Issue Report

Knight #457362

Report created on February 19, 2021

No. 1 OPEN

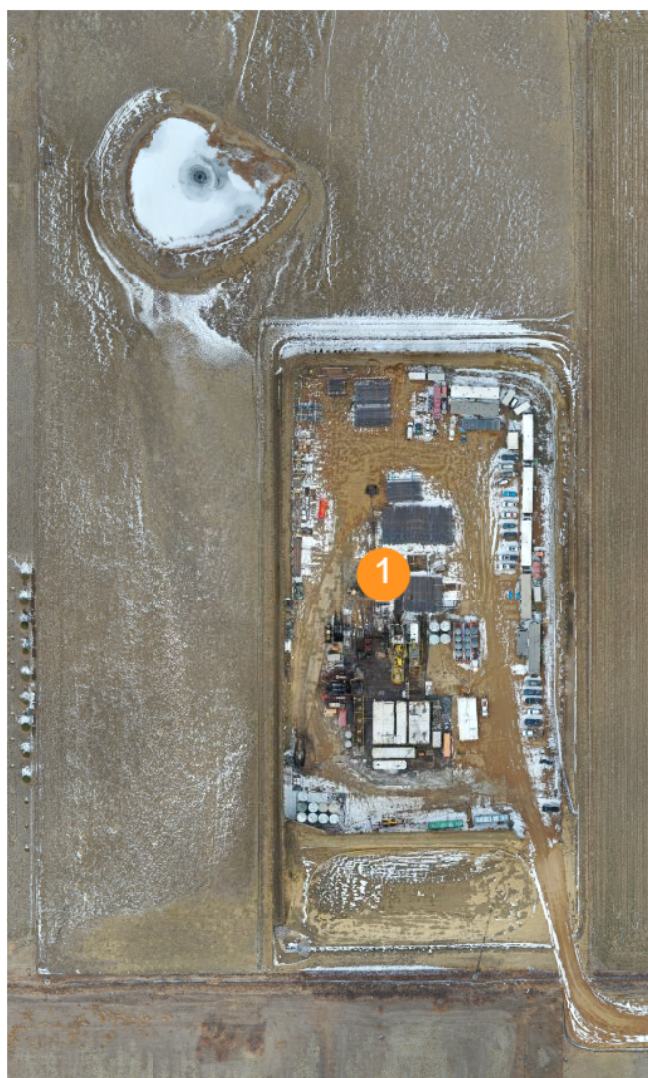
Open/Candlestick flare. Drilling corrective action: 903 b. (3) Combustors will be located a minimum of 100 feet from the nearest surface hole location and enclosed.
